ORIGINATION FORM

Proposed Revisions to a Standard Plans Index
(Please provide all information — Incomplete forms will be returned)

Index Number: 102-660
Sheet Number (s): 1
Index Title: Pedestrian Control for Closure of Sidewalks

LAST REVISION 11/01/17	DESCRIPTION:		FY 2020-21 STANDARD PLANS	PEDESTRIAN CONTROL FOR CLOSURE OF SIDEWALKS	INDEX 102-660	SHEET 1 of 1
--------------------------------------	--------------	--	------------------------------	--	------------------	-----------------

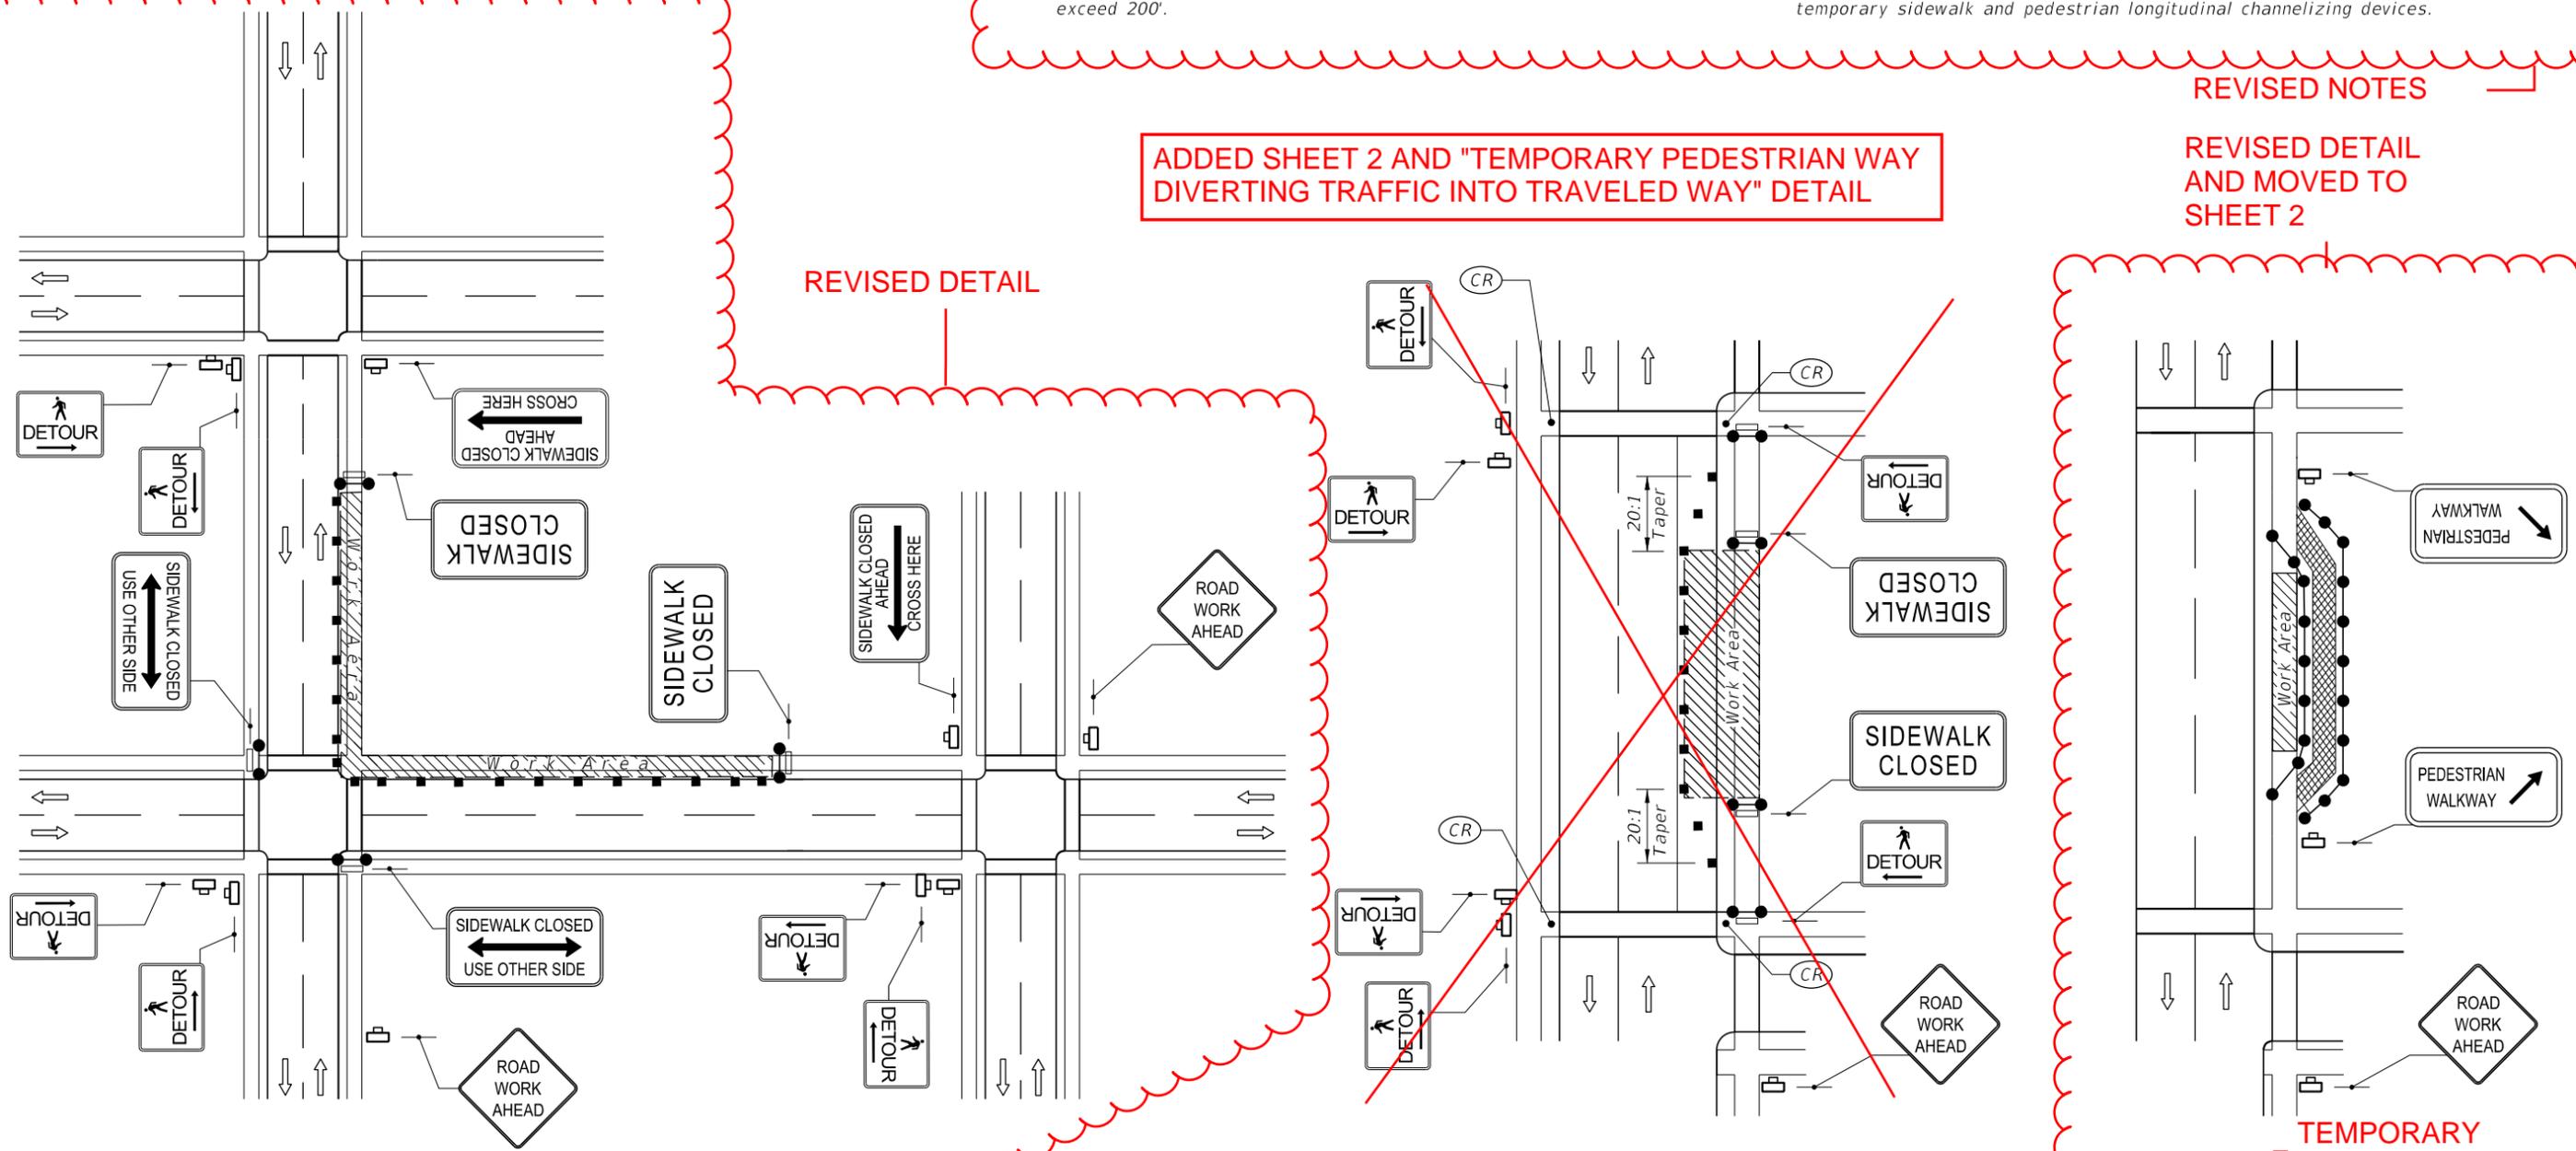
Sheet 1: Updated Symbols; Revised 'Pedstrian Detour' Detail; Revised Notes; Moved 'Sidewalk Diversion' Detatil to Sheet 2; Deleted 'Sidewalk Detour' Detail; Renamed Index.

UPDATED SYMBOLS

REVISED NOTES

REVISED DETAIL AND MOVED TO SHEET 2

ADDED SHEET 2 AND "TEMPORARY PEDESTRIAN WAY DIVERTING TRAFFIC INTO TRAVELED WAY" DETAIL

REVISED DETAIL

LAST REVISION 11/01/20	REVISION	DESCRIPTION:		FY 2021-22 STANDARD PLANS	SIDEWALK CLOSURE	INDEX 102-660	SHEET 2 of 2
---------------------------	----------	--------------	--	------------------------------	------------------	------------------	-----------------

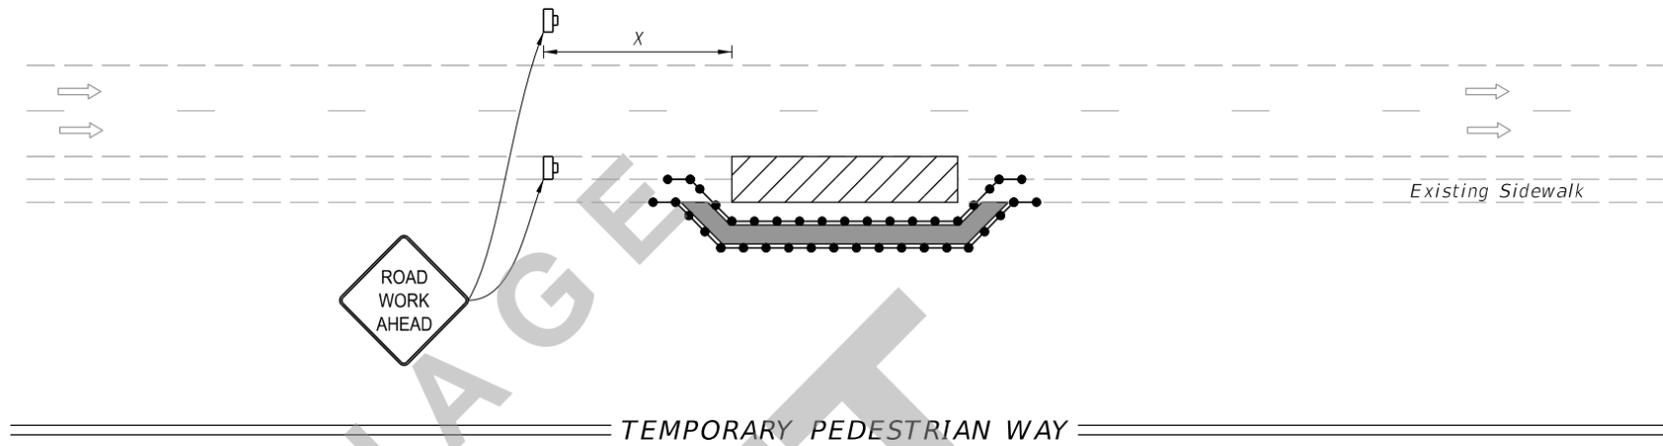
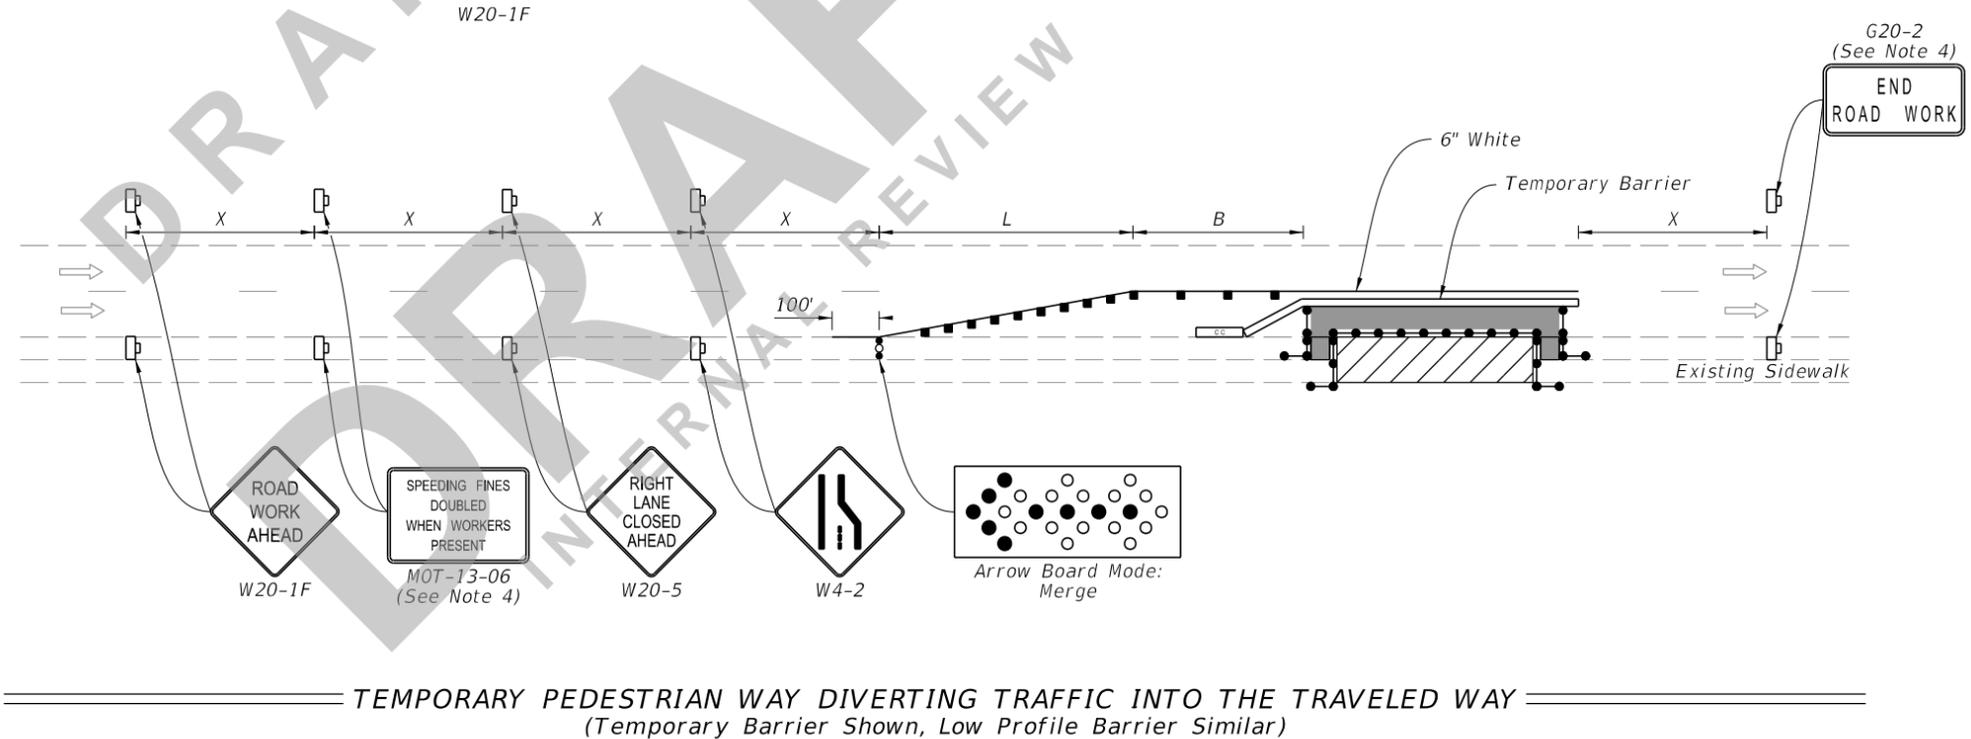
Sheet 2: Added Sheet 2; Added 'Temporary Pedestrian Way Diverting Traffic Into Traveled Way' Detail; Added and Revised 'Sidewalk Diversion' Detail from Sheet 1.
